RE: Indian Point Unit No. 2  
Docket No. 50-247

MECHANICAL ENGINEERING BRANCH

REQUEST FOR ADDITIONAL INFORMATION

TABLE 1  
IPP - MAXIMUM FORCES ACTING ON A REACTOR VESSEL SUPPORT

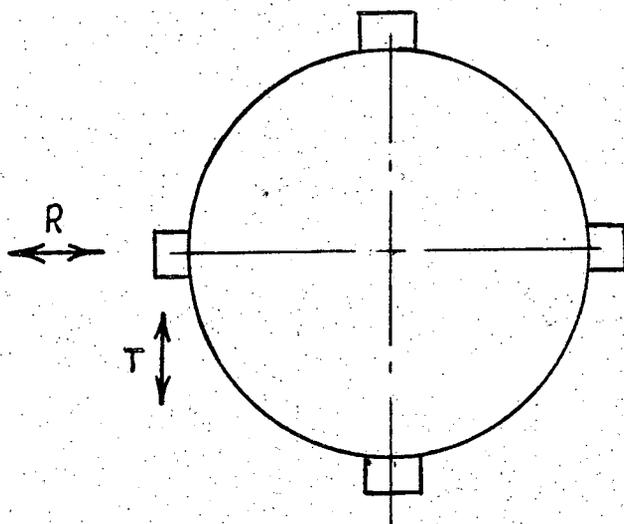
2. Specify the detail design loads used in the original design analyses of the reactor supports giving magnitude, direction of application and the basis for each load. Also provide the calculated maximum stress in each principal element of the support system and the corresponding allowable stresses.

Table 1 shows the maximum loads and combined loads derived from the application of this criteria to the reactor vessel supports. These loads are

applied in the analysis to each individual support. Since the applied lateral loads on the reactor vessel are resisted by two support shoes, the total lateral load applied to the reactor vessel is twice that applied to each shoe. The highest lateral load the reactor vessel will see given the above described design basis is 2,218 kips. The steam generator supports and the reactor coolant pump supports attached to the unbroken loops also resist the applied lateral loads. This effect which was conservatively not included, is significant as it will reduce the loads transferred to the vessel support, since the total loads would be redistributed to all the supports.

R - RADIAL  
T - TANGENTIAL  
P - VERTICAL

PIPE BREAK CASE II IS BETWEEN PUMP AND ELL ON REACTOR NOZZLE

PIPE BREAK CASE III IS AT STEAM GENERATOR INLET

EARTHQUAKE IN Z DIRECTION ACTS NORMAL TO REACTOR COOLANT OUTLET LINE.
